RE: Hanson Tweed Sand Plant Expansion, Cudgen Tweed LGA, (SSD 10398)

Enclosure: Attachment 1: Detailed BCD Comments – Hanson Tweed Sand Plant Expansion at Cudgen (SSD 10398)

- Environmental Impact Statement (EIS) Hanson Tweed Sand Plant Expansion Phase 5 to Phase 11 prepared by Zone Planning Group Pty Ltd March 2021
- Biodiversity Development Assessment Report (BDAR) prepared by JWA Ecological Consultants March 2021
- Concept Rehabilitation & Landscape Management Plan (CRLMP) prepared by JWA Ecological Consultants March 2021 (Appendix H2)

Figure 1. Figure 9 in the BDAR describes an approved extraction area that includes areas required to be restored and rehabilitated under the current approval.

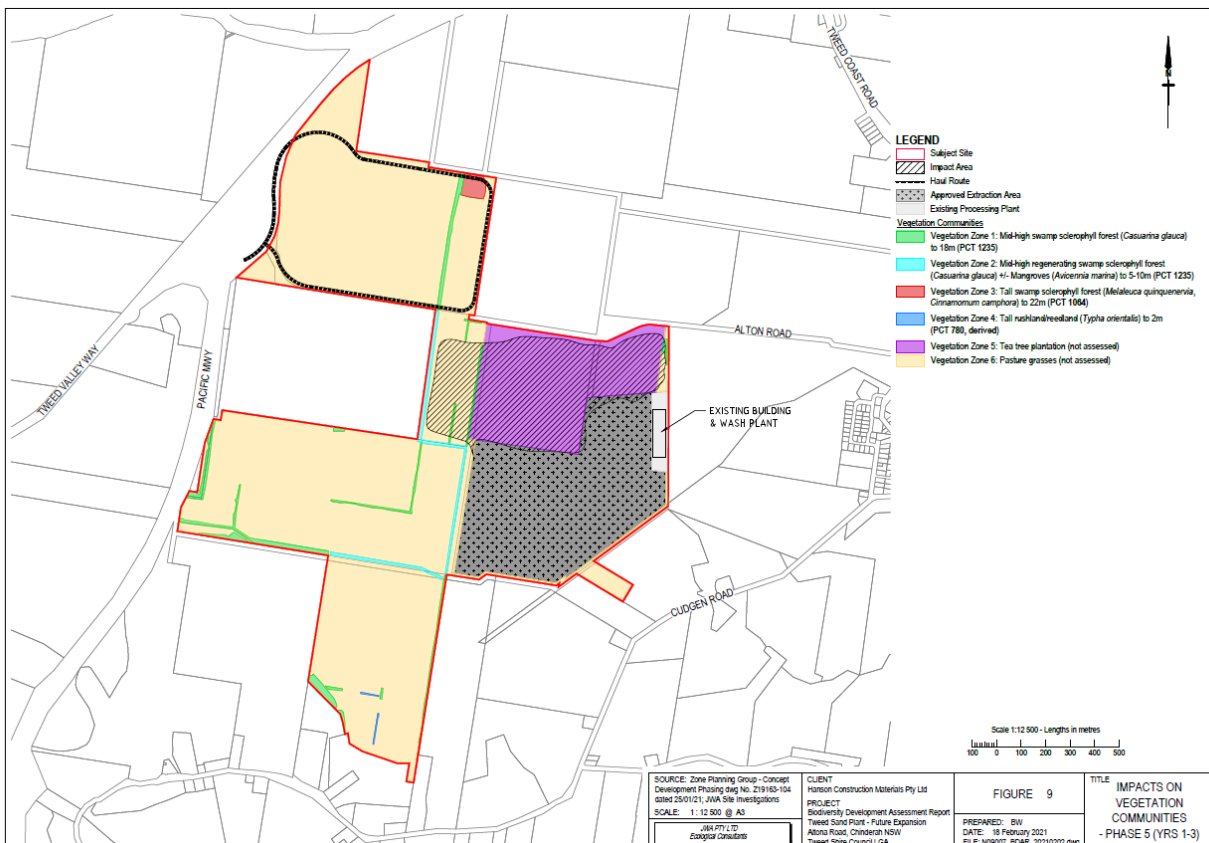
The BDAR incorrectly identifies an “Approved Extraction Area” in Figures 8-15 (see Figure 1 below). This includes areas that were required to be rehabilitated in accordance with previous consent and, in particular, the revised Rehabilitation and Landscape Management Plan (RLMP) prepared by JWA (2019).

1. The BDAR must be amended to show the correct Approved Extraction Area and existing rehabilitation areas in Figures 8-15.
2. The areas that were required to be rehabilitated in accordance with the current consent and the revised Rehabilitation and Landscape Management Plan (RLMP) prepared by JWA (2019), and that will be impacted by this proposal, must be quantified. Offsets for impacts that

Figure 2. Figure in the Revised Rehabilitation and Landscape Management Plan (RLMP) prepared by JWA (2019) describing wetland and riparian rehabilitation areas in the final phase of the current sand mining operation.

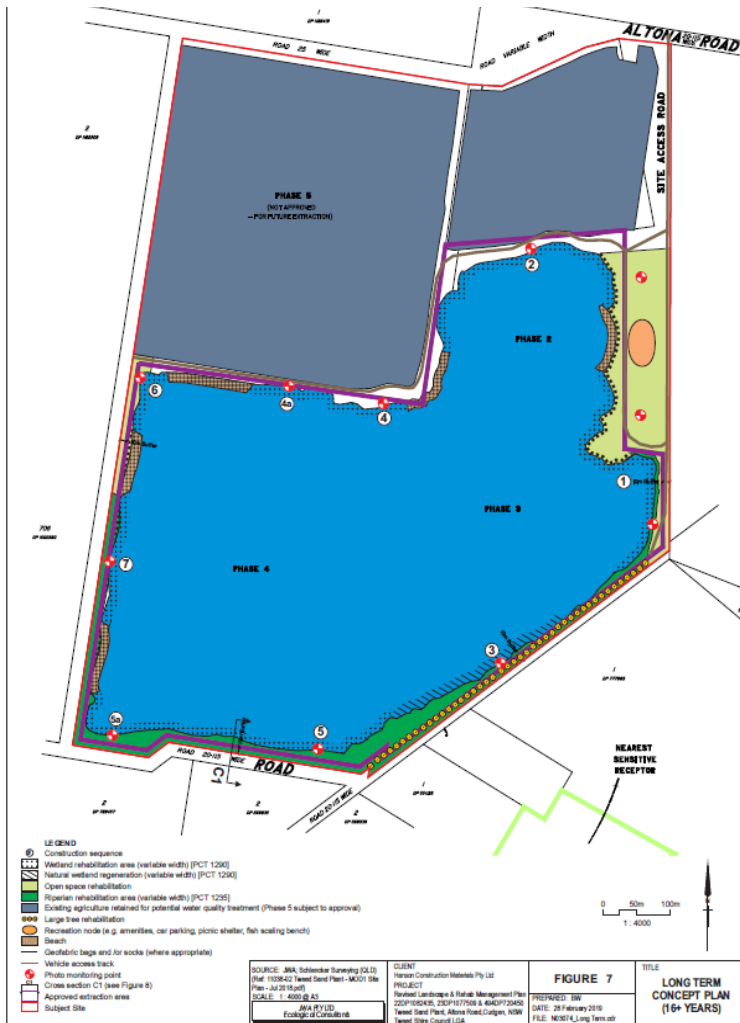
Our BCD project specific Environmental Assessment Requirements (EARs) included that impacts on existing rehabilitation areas should be offset if they could not be avoided. Wetland, riparian and open space rehabilitation areas were required to be rehabilitated in accordance with the RLMP as shown in Figure 2 below.

Although rehabilitation of some of these areas (i.e. Phase 2 areas numbered 2, 4 and 4a) has not occurred on the premise that an expansion of the development was proposed, the rehabilitation of all these areas was a requirement of the consent and the impacts on these areas needs to be assessed and, where appropriate, offset.

If impacts on these areas cannot be avoided, offsets for the loss of these areas should be calculated using the Biodiversity Assessment Method Calculator (BAM-C) according to the most appropriate Plant Community Type (PCT) present, noting some areas were identified as being aligned to PCT 1290. The EIS and BDAR should document the offset requirements and demonstrate how the offsets will be delivered.

Figure 3. BioNet koala records (blue dots with the late date entry) in relation to the development site.

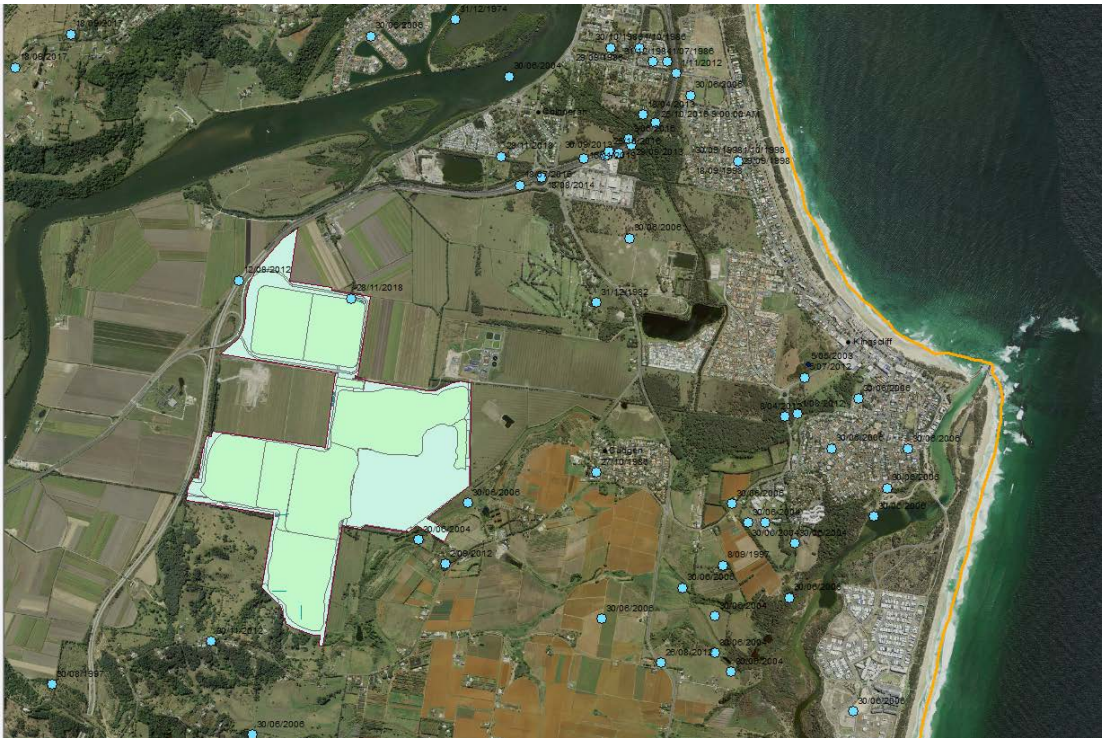
There are Bionet Koala (*Phascolarctos cinereus*) records in the locality including three in the adjoining property to the south dated 2004, 2006 and 2012 and to the north dated 2012 and 2018 (see Figure 3 below). Although the location of the northern 2018 record is shown on the site this may not be accurate. The northern 2012 record is identified as being a vehicle collision on the Pacific Highway southbound at the Cudgen exit, Cudgen. Koalas are known to occur in the area and may move across the site, as well as possibly finding habitat on the development site such as the area of vegetation in the north. The BDAR has not considered these records or the likelihood of koalas being present and moving through parts of the site.

3. The BDAR requires greater consideration of indirect and prescribed impacts such as lighting, site disturbance, increased and relocated traffic and loss of connectivity and impediments to movement for threatened species including the Koala.

Figure 5. Recreational area in the current approval as described in the RLMP that is to be removed.

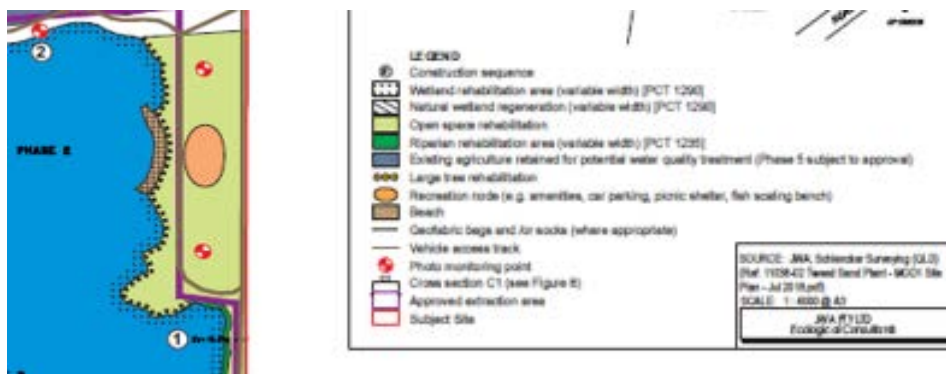
It also appears the proposed development will remove the Open Space Recreational area that was part of the current approval in the eastern part of the site as shown in the RLMP extract below (see Figure 5 below).

As described in the RLMP Legend, rehabilitation in this eastern area included a beach, recreational node (e.g. amenities, car parking, picnic shelter, fish scaling bench) and open space rehabilitation. According to the RLMP this area was to be planted in accordance with an approved Landscape Plan with locally occurring native species in order to provide habitat and foraging resources for native fauna as well as improving the visual amenity of the subject site.
